March 20, 2023

**SUBJECT: MERGE 56 – UNIT 10: LOTS 1, 2, 3, 4, 5 & 6, UNIT 4: LOTS 3 & 4 – PDP #2 (PRJ-1059203)**  
**ADDENDUM LETTER TO DRAINAGE REPORT**

This letter is to address the proposed changes to the previously approved Merge 56 Unit 1 (PTS #697235) and Unit 2 (PTS #697236) Construction Change 'B' Storm Water Quality Management Plan.

MERGE 56 - ONSITE UNITS 1 AND 2  
PROPOSED DRAINAGE EXHIBIT

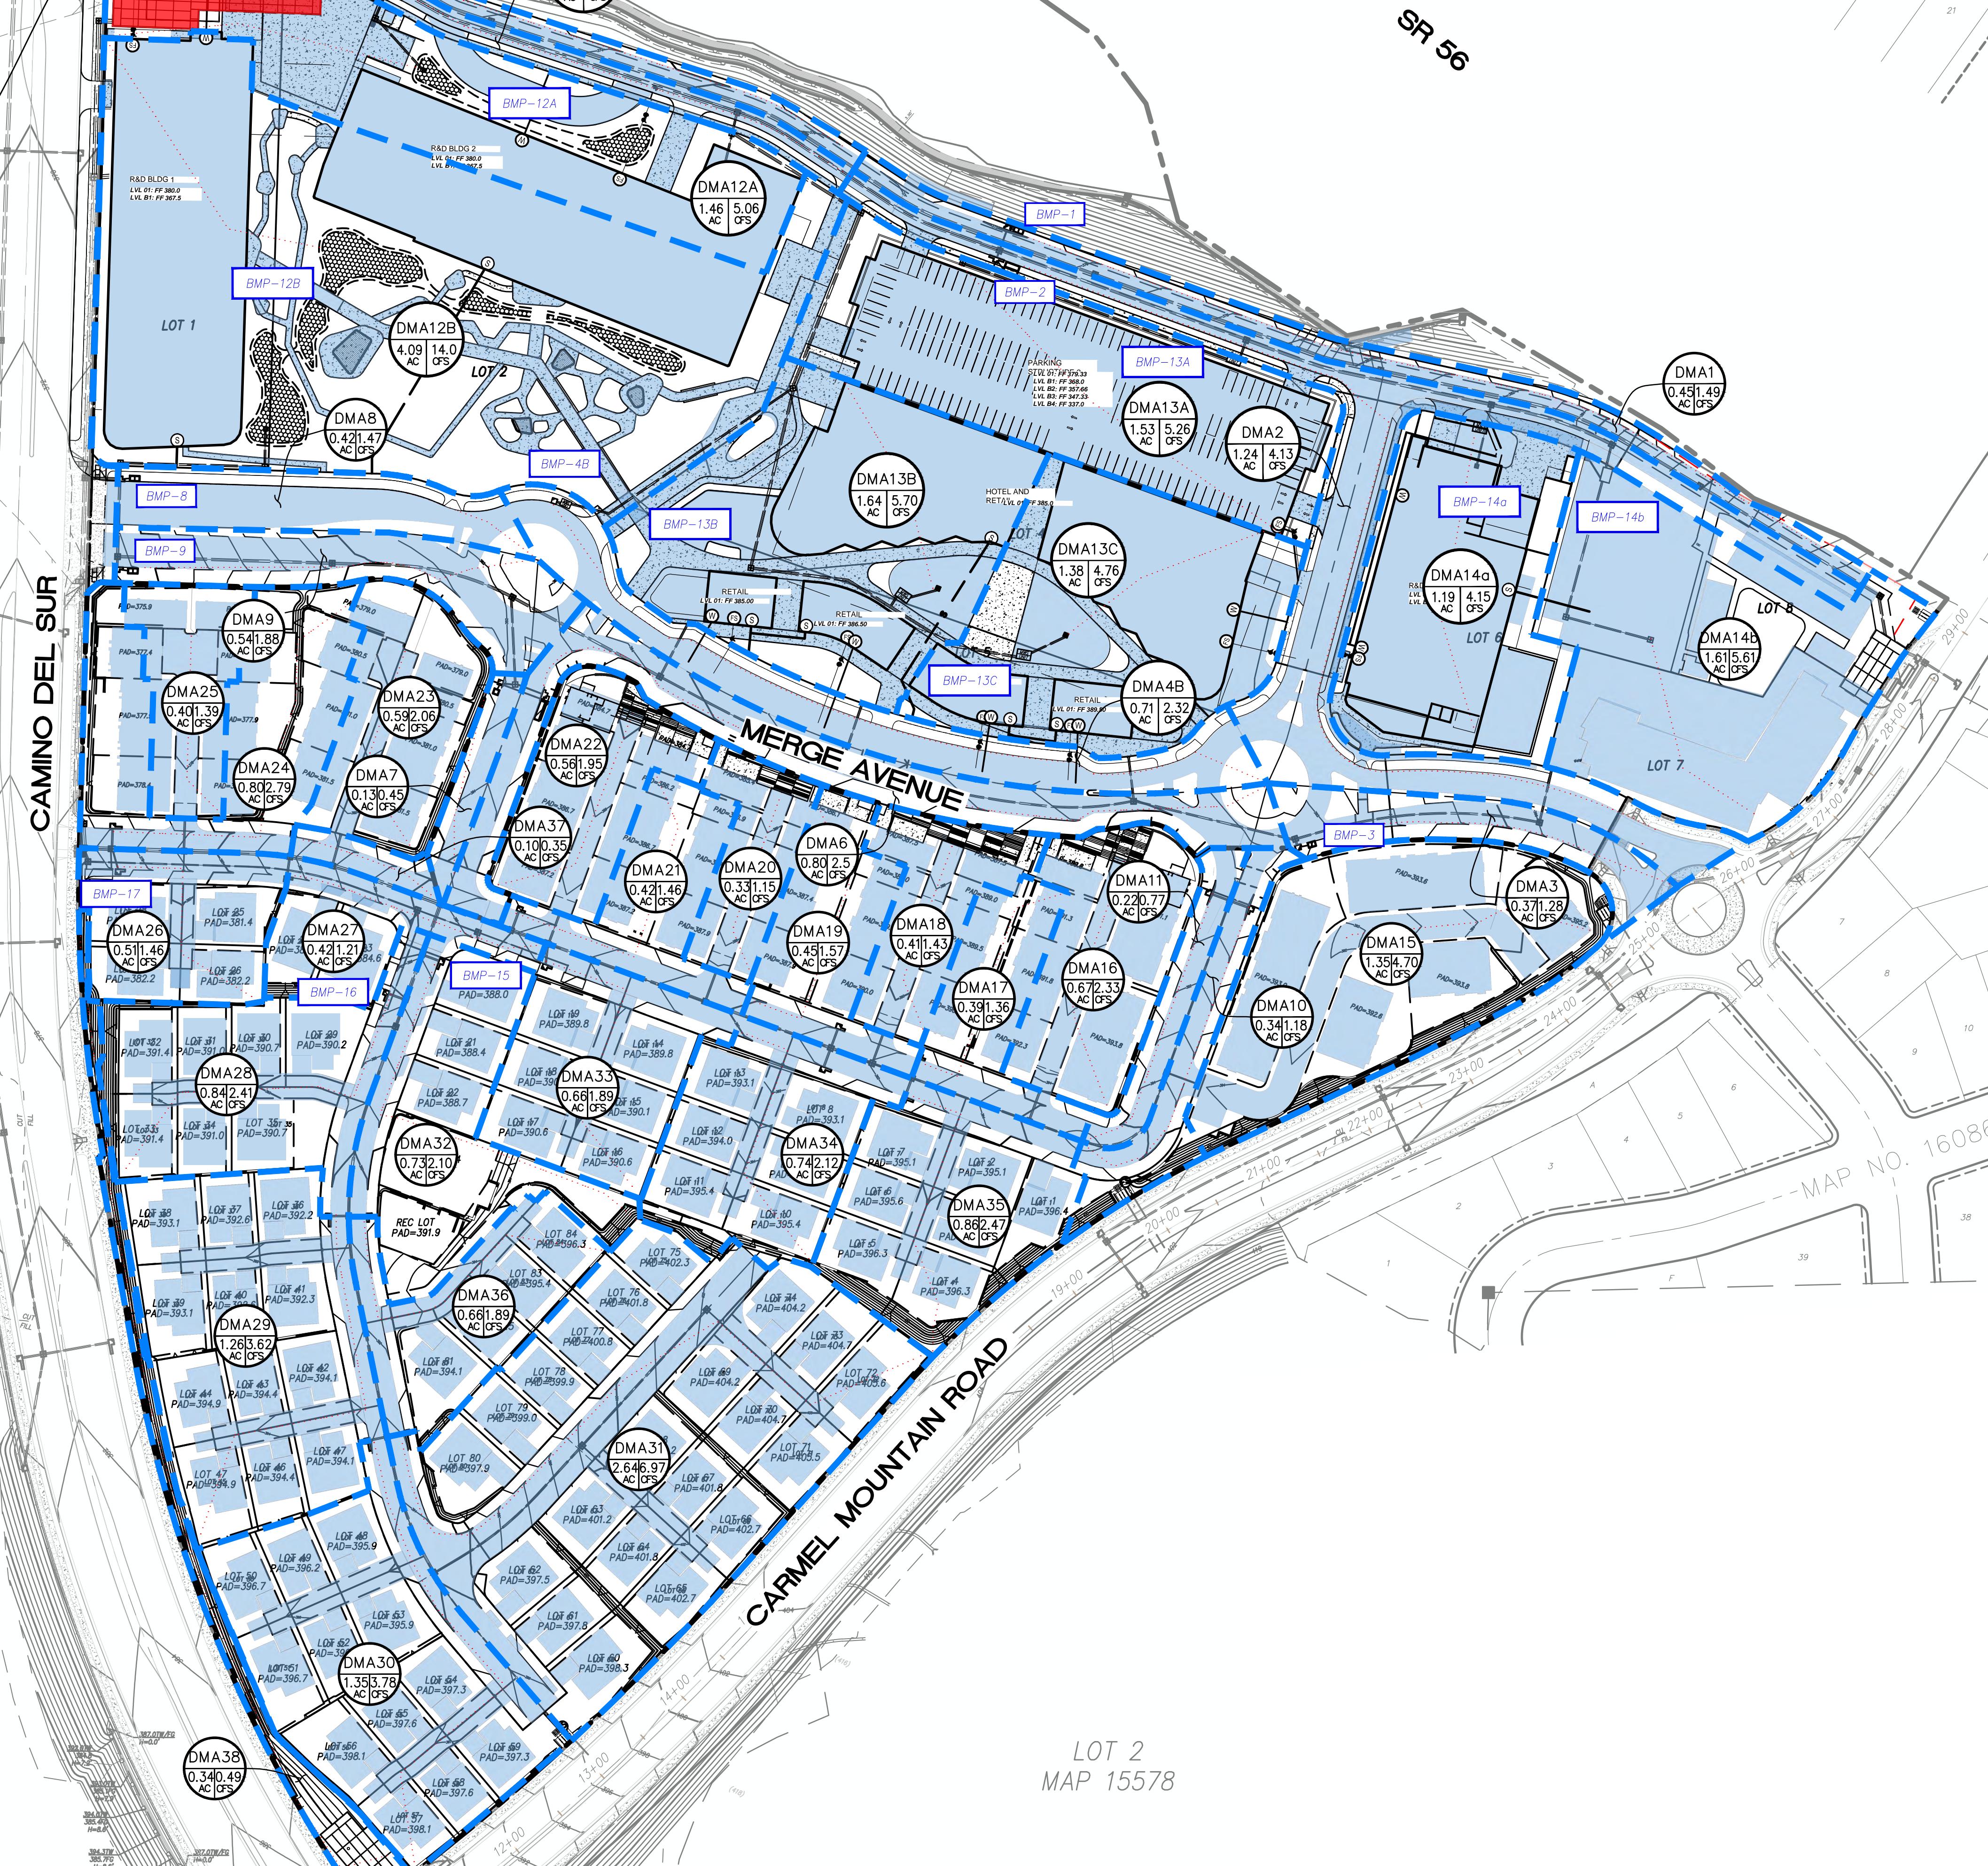
**Proposed PDP:** This PDP amendment proposes changes to the Drainage Management Areas (DMA's) of Unit 10 of Merge 56, changing some directionality and flow. Unit 10, Lots 1, 2, 3, 4, 5, and 6 will be affected as DMA 4, 12, and 13 will all be changed. DMA 4 and 12 are split into 2 separate DMA's and 13 is split into 3 DMA's. DMA 4 located in Unit 1 has been split into two separate DMA's – 4A and 4B. Runoff from 4A will be carried north to Street T by storm drain to Modular Wetlands System that is already

installed, BMP 4A, where it will be treated and discharged into the backbone storm drain system. Runoff from 4B will utilize a MWS unit, will be conveyed along Street M, and will be discharged into the backbone storm drain system. DMA 12, located in Unit 1 has been split into two separate DMA's – 12A and 12B. Runoff from 12A will be conveyed by area drains north to Street T into a biofiltration basin, BMP 12A, where it will be treated and discharged into the backbone storm drain system. Runoff from DMA 12B will be conveyed by area drains South to Street M into a biofiltration basin, where it will be treated and discharged into the backbone storm drain system. DMA 13, located in Unit 1 has been split into three separate DMA's – 13A, 13B, and 13C. Runoff from 13A, 13B, and 13C be conveyed by storm drains north to Street T to their respective BMP Modular Wetlands Systems. DMA 14A, has an updated drainage assessment where it will utilize a MWS unit. DMA 14A will flow north to Street T, where it be treated and discharged into the backbone storm drain system. Runoff is ultimately conveyed by private storm drain to Camino Del Sur where all the DMA's will confluence at the vault. It will then connect into the public storm drain at POC 'A' which will then drain westward into Deer Canyon.

AREA=36.51 AC  
Before Detention:  
 $Q_{50}=94.24 \text{ CFS}$   
 $V_{50}=36.32 \text{ FPS}$

After Detention:  
 $Q_{50}=41.31 \text{ CFS}$   
 $V_{50}=15.10 \text{ FPS}$
